**Re: *Addendum No. 2***  
***Red Creek Sanitary Sewer Improvements, Project No. 280-S***  
***Lake County Board of County Commissioners***

Date: February 22, 2024

## Huntington Road Pavement Resurfacing

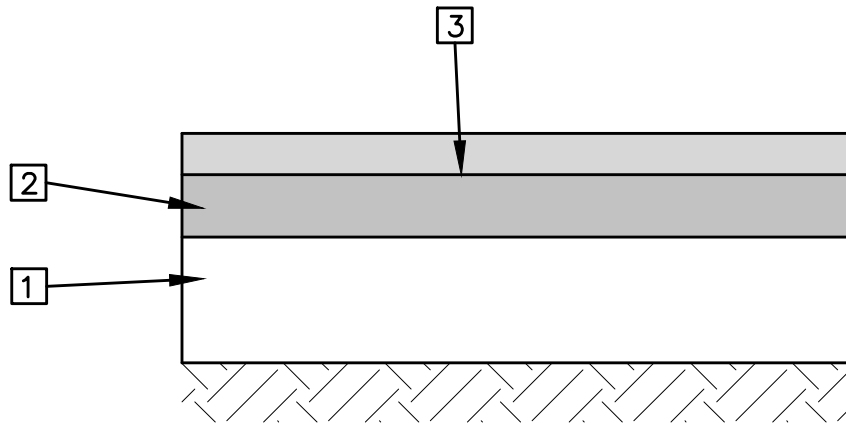
1. Contract B – Alternate – If awarded, the contractor shall be responsible for the resurfacing of Huntington Road at the completion of the project. Refer to enclosed details. Refer to enclosed map of limits of resurfacing. After milling, 253 Full Depth Pavement Repair may be directed by the Engineer. This Repair shall be per the bottom half of the enclosed pavement detail. The 6” of ODOT 304 Aggregate shall be paid via Ref. No. 1, ODOT 204 Excavation of Subgrade and Ref. No. 2, ODOT 204 Granular Material, As Per Plan. Ref. No. 3, Pavement Repair, As Per Plan shall consist of the two courses of Type 1 Intermediate Course and Type 1 Surface Course.

1. Contract B shall mill 1.5" of existing pavement and replace with 1.5" of ODOT Item 441 Type 1 Surface Course for the full length as noted above.
2. Total length of Huntington Road to be resurfaced shall be 932 feet from Mantle Road to the western end of Huntington Road. The limits shall include the aprons at the intersection of Huntington Road and Mantle Road.
3. Resurfacing shall be full width of pavement.
4. Full depth replacement shall be as determined by the Owner.
5. Contractor shall saw cut areas to have full depth replacement in neat, straight lines. The pavement shall be removed, and the subbase restored and compacted per ODOT Item 203.

**RED CREEK WWTP  
GENERATOR FOUNDATION  
180304**

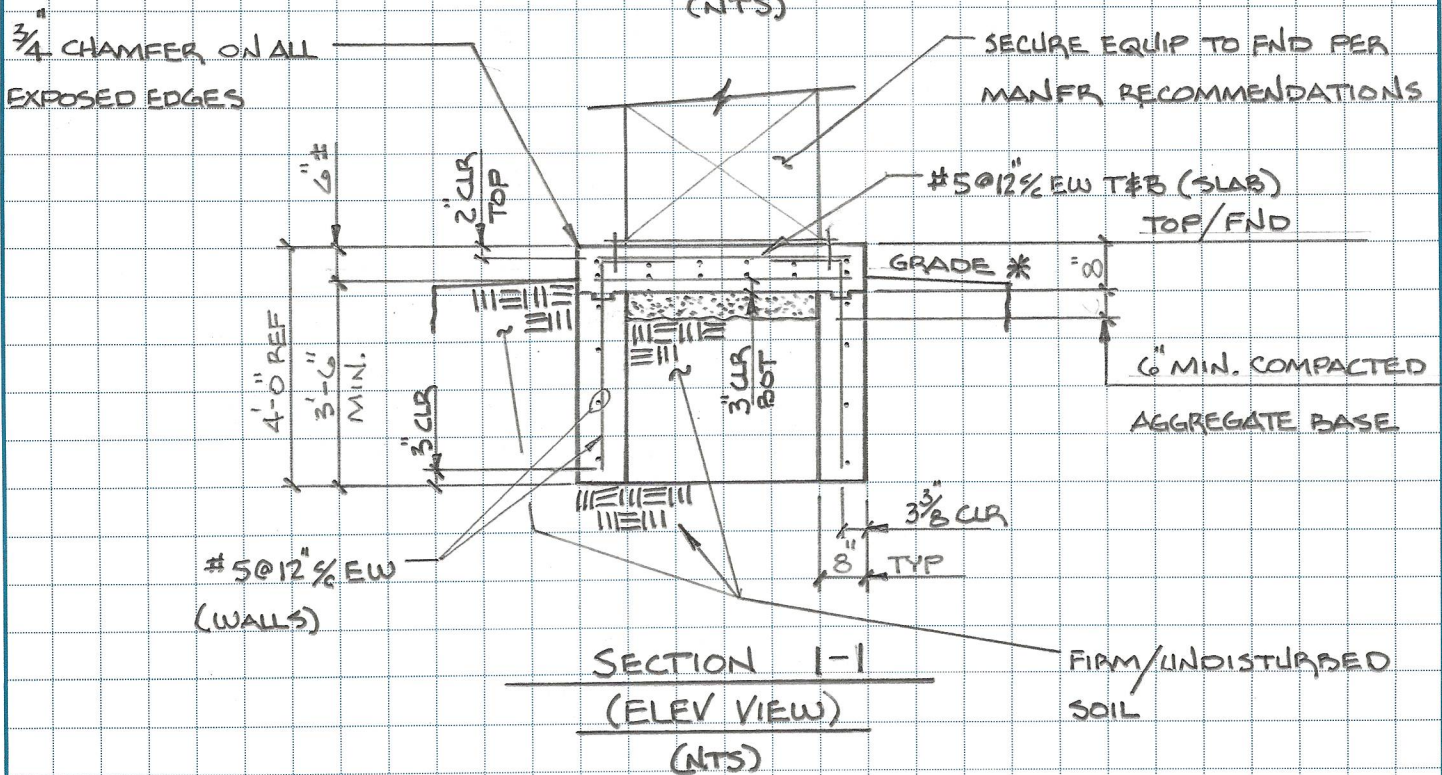
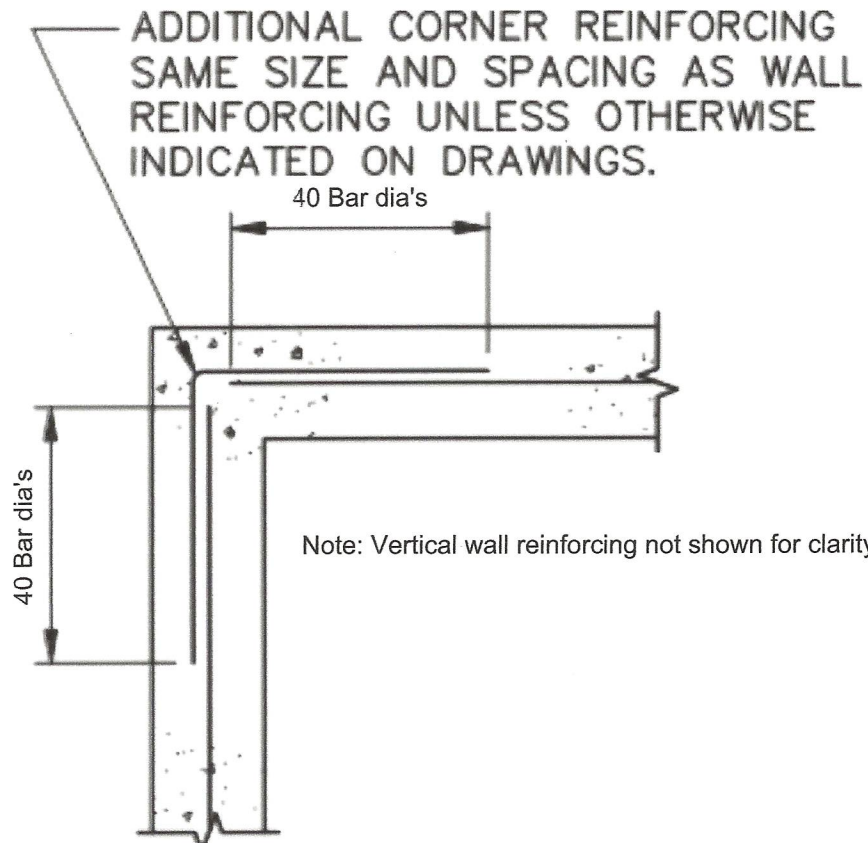
1. On Sheet 48 of 52, **delete** Note 1 under Type C Pavement Replacement.
2. Add the Generator Foundation Sketch Q17 inadvertently left out of Addendum 1.
